Grading Plan Approved as shown and/or noted
THOMAS P. GILLES, P.E.
Lake County Engineer
By GJH Date 42695

Site Plan

For STEVE ANDERSON
S/L 150 Quail Hollow Subd. No.3
Concord, Lake County, Ohio
Vol. 21 Pg. 33

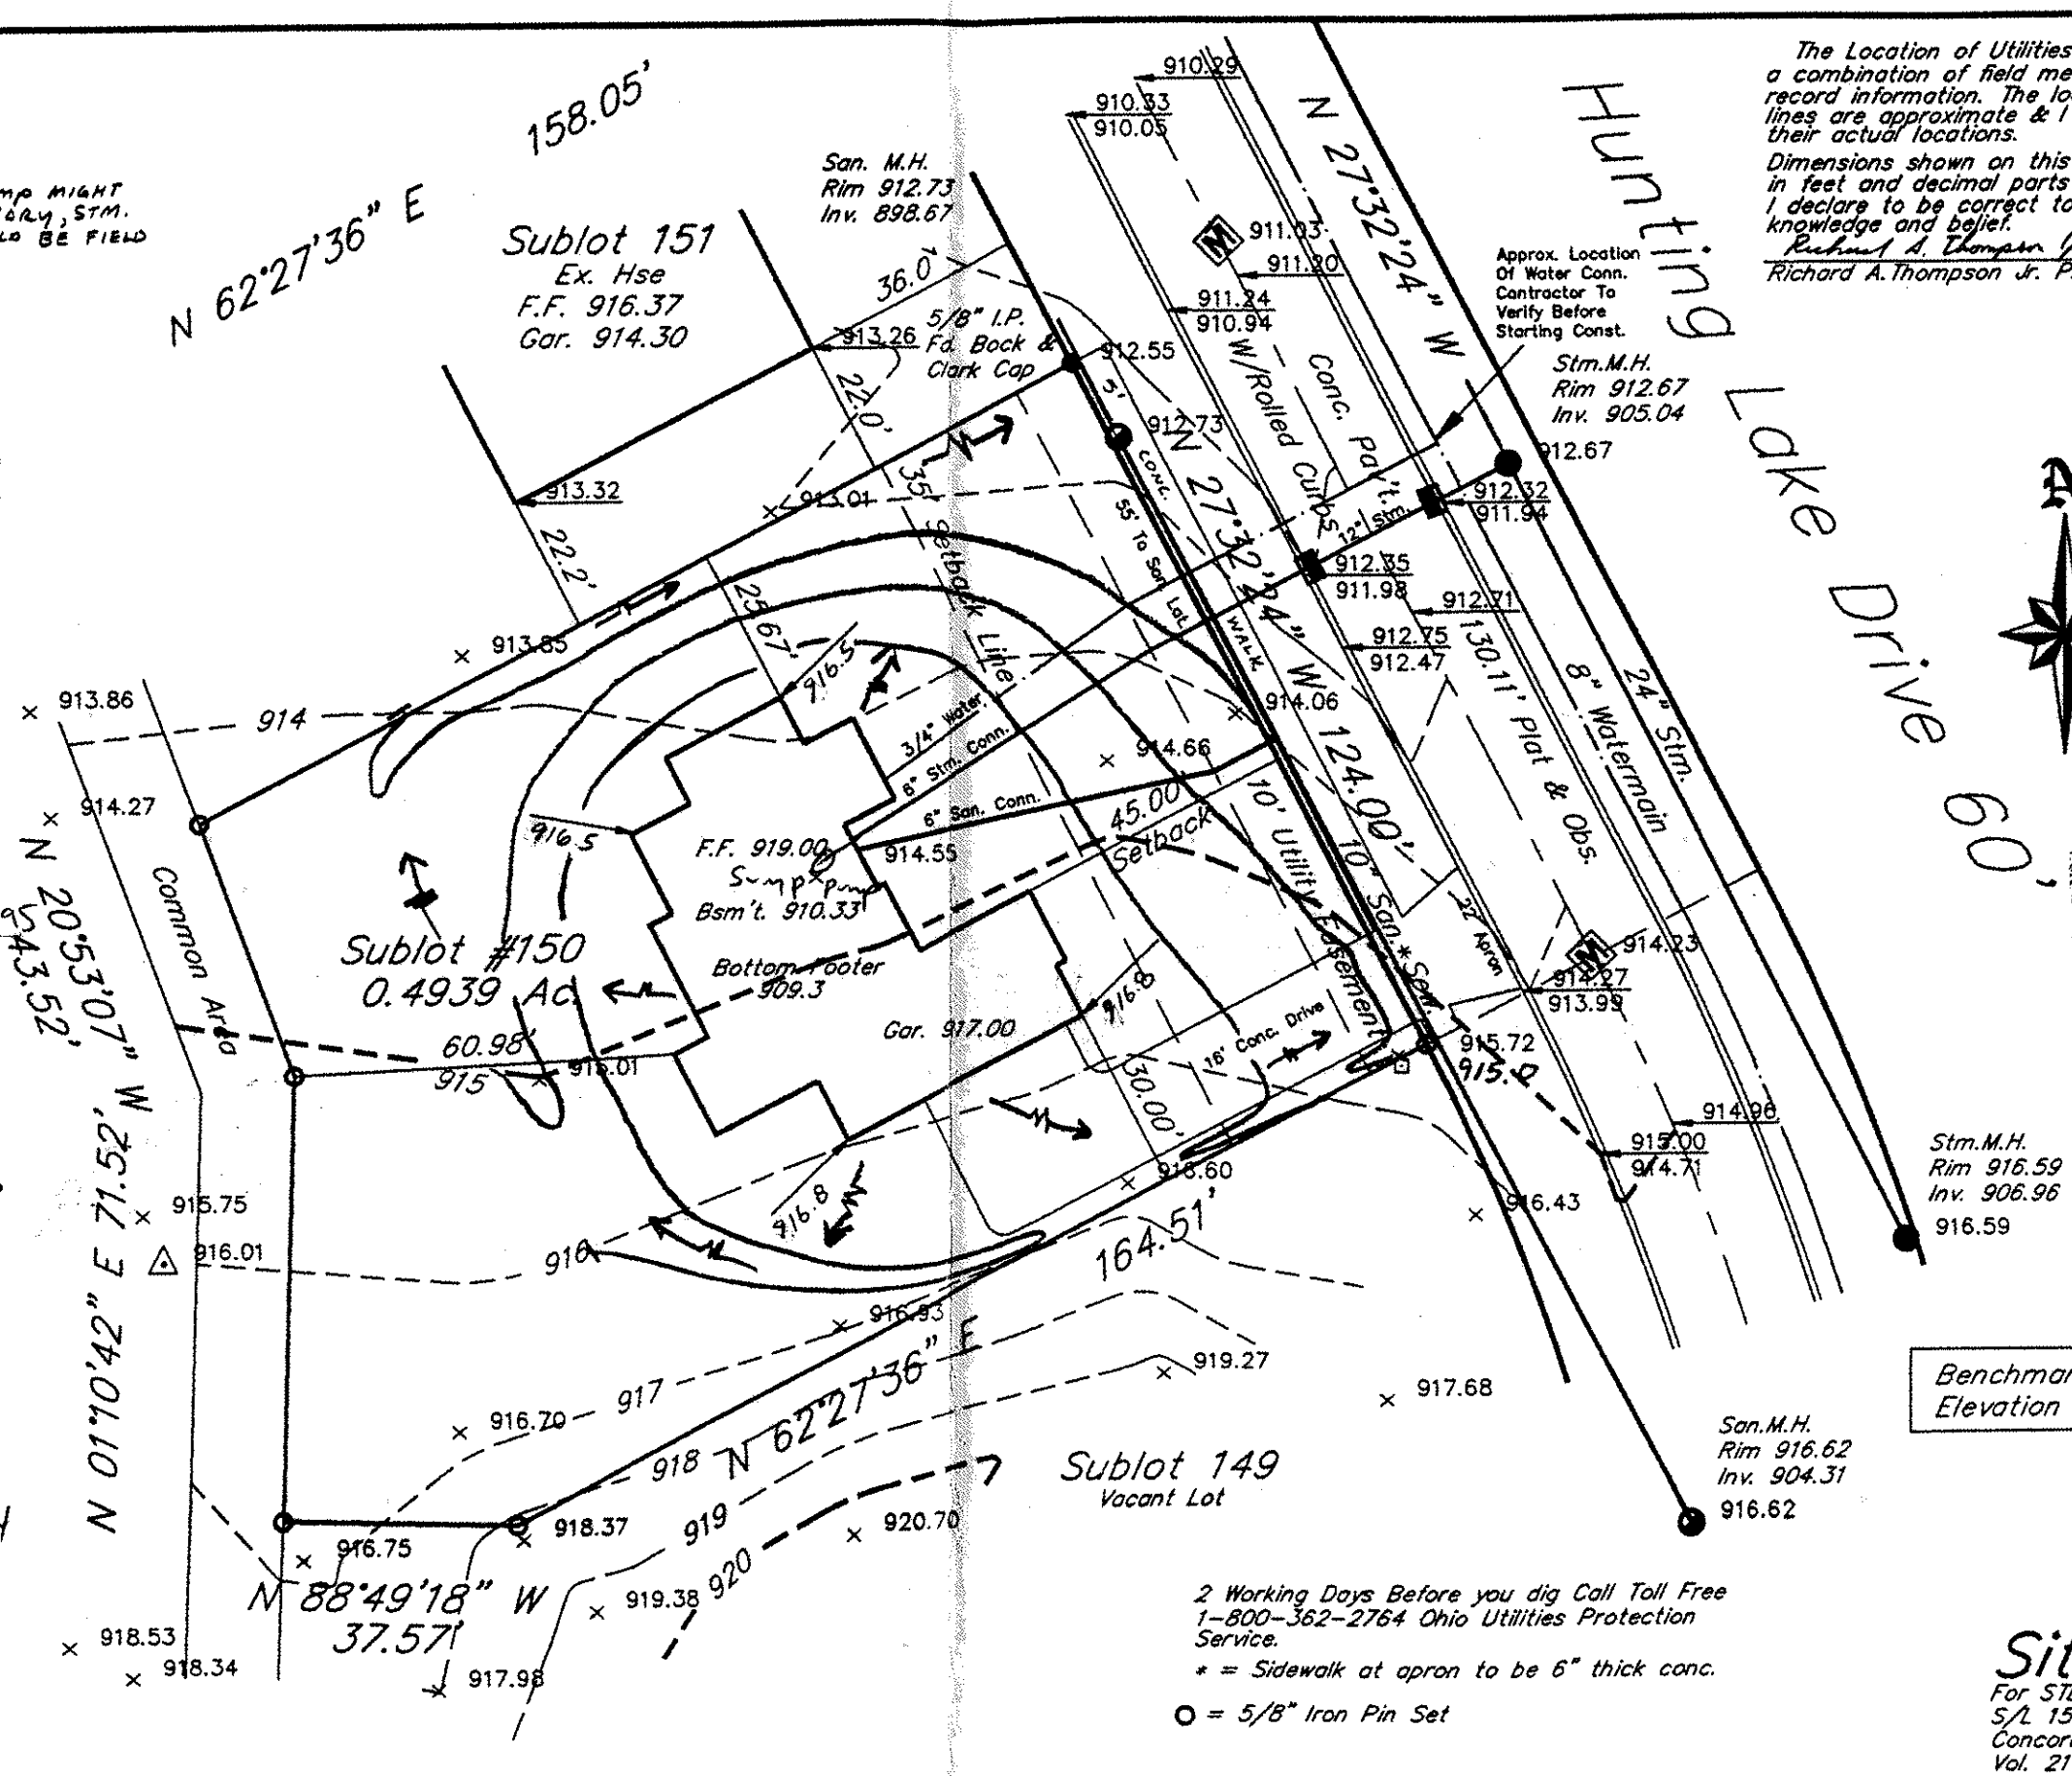
Stm. @ Inlet ± 907.9
Stm. Inv. at Hse. ± 908.7 (Sump pump might be necessary, stm. conn. should be field verify)

Discharge Sump pump to Storm lateral.
